MEMORANDUM FOR: D. F. Ross, Jr., Assistant Director for Reactor Safety, DSS
 THRU: Thomas M. Novak, Chief, Reactor Systems Branch, DSS
 FROM: Gerald Mazetis, Section Leader, Reactor Systems Branch, DSS
 SUBJECT: 2/17/77 APPEALS MEETING WITH TOLEDO EDISON COMPANY ON
 DHR ISOLATION VALVES

A staff position previously transmitted to TECO stated that locking out power to the DHR isolation valves during shutdown was not acceptable. The basis for this decision was:

POWER OFF
DHR VALVES

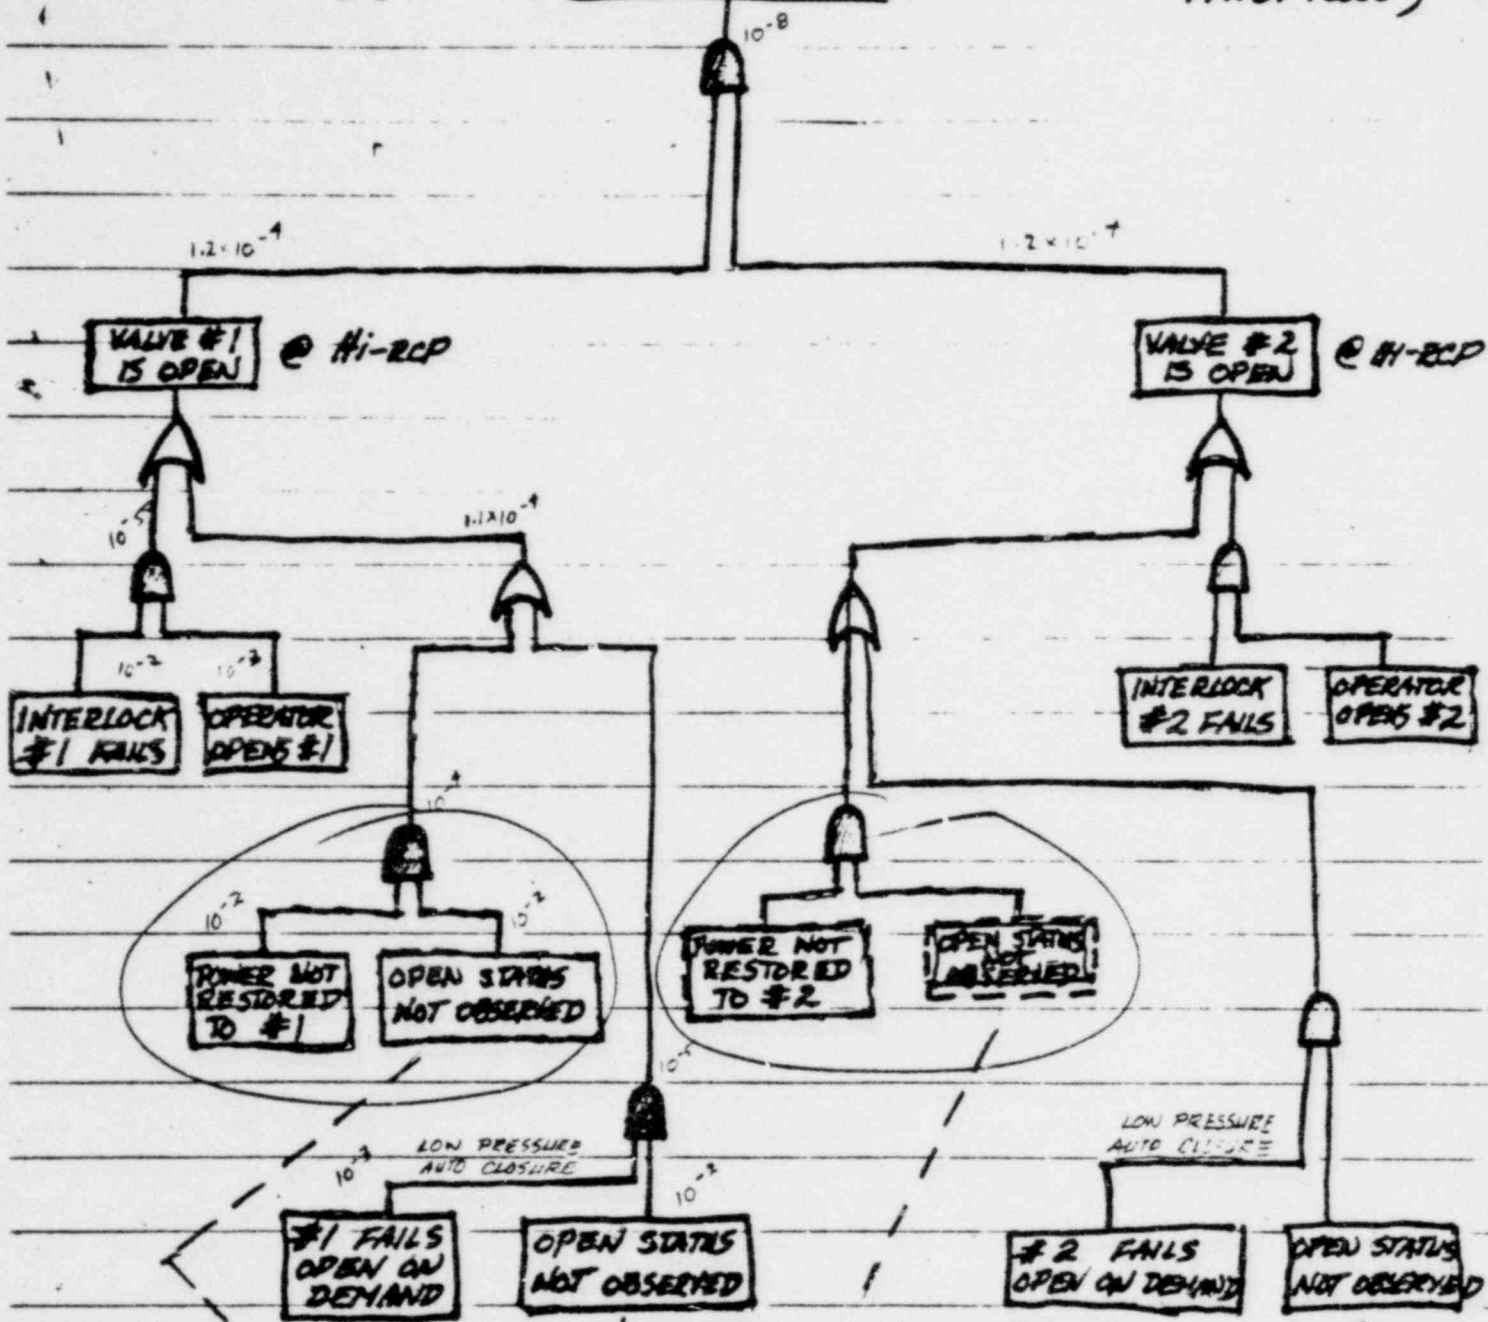
-RESPONSE: Disagree. As shown in the attached diagram, by disconnecting the power to these valves, an additional failure mode is introduced which is not present when power is available. This additional failure mode (circled) is the operator forgetting to restore power on one, or both, valves.

It should be noted that the complete spectrum of failure modes was not included in the diagram, such as common mode failures and valve disc separations; however, the point is that the diagram shows that an additional failure mode is introduced in the overall scheme. More work would have to be performed before a rigorous assessment could be made of exactly what this additional failure mode would introduce in terms of its finite contribution to the overall probability estimate of a LOCA outside containment.
